## Urgent Field Safety Notice Product Correction

March 7, 2019

Product Name	List Number	Serial Number	UDI
Alinity ci-series System Control Module (SCM)	03R70-01	All	N/A
Level Sensor, Bulk Solution	04S68-01	All	N/A
Accessory kit, Alinity i	03R66-01, 03R66-02	All	N/A
Accessory kit #2, Alinity c	03R69-01, 03R69-02	All	N/A

#### Alinity ci-series issues resolved in software version 2.6.0

Figure 1. Level Sensor, Bulk Solution identification label

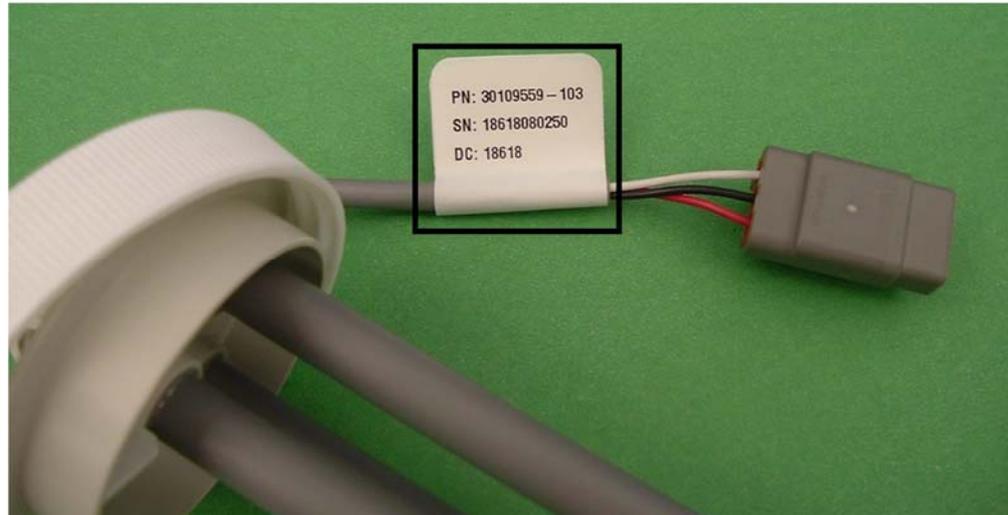
3. Bulk Solution Level Sensor related actions (refer to **Appendix B** for additional information):
  - a. If LN 04S68-01 Level Sensor, Bulk Solution is installed in the Alinity i Trigger or Pre-Trigger bulk solution reservoirs, Abbott recommends these sensors be replaced with a Level Sensor, Bulk Solution, LN 04S68-02 before further test processing is performed.

- If the part is in the box, the list number (04S68-01 or 04S68-02) is printed on the label
- If the part is removed from the box or installed on the Alinity ci series, the part number is printed on a label attached to the electrical connection for the part. See Figure 1 and Table 1 below.

List Number (LN)	Part Number (PN)	Instructions
04S68-01	30109559-102	Remove and replace any Level Sensor, Bulk Solution, LN 04S68-
04S68-02	30109559-103	01/PN 30109559-102 with LN 04S68-02/PN 30109559-103
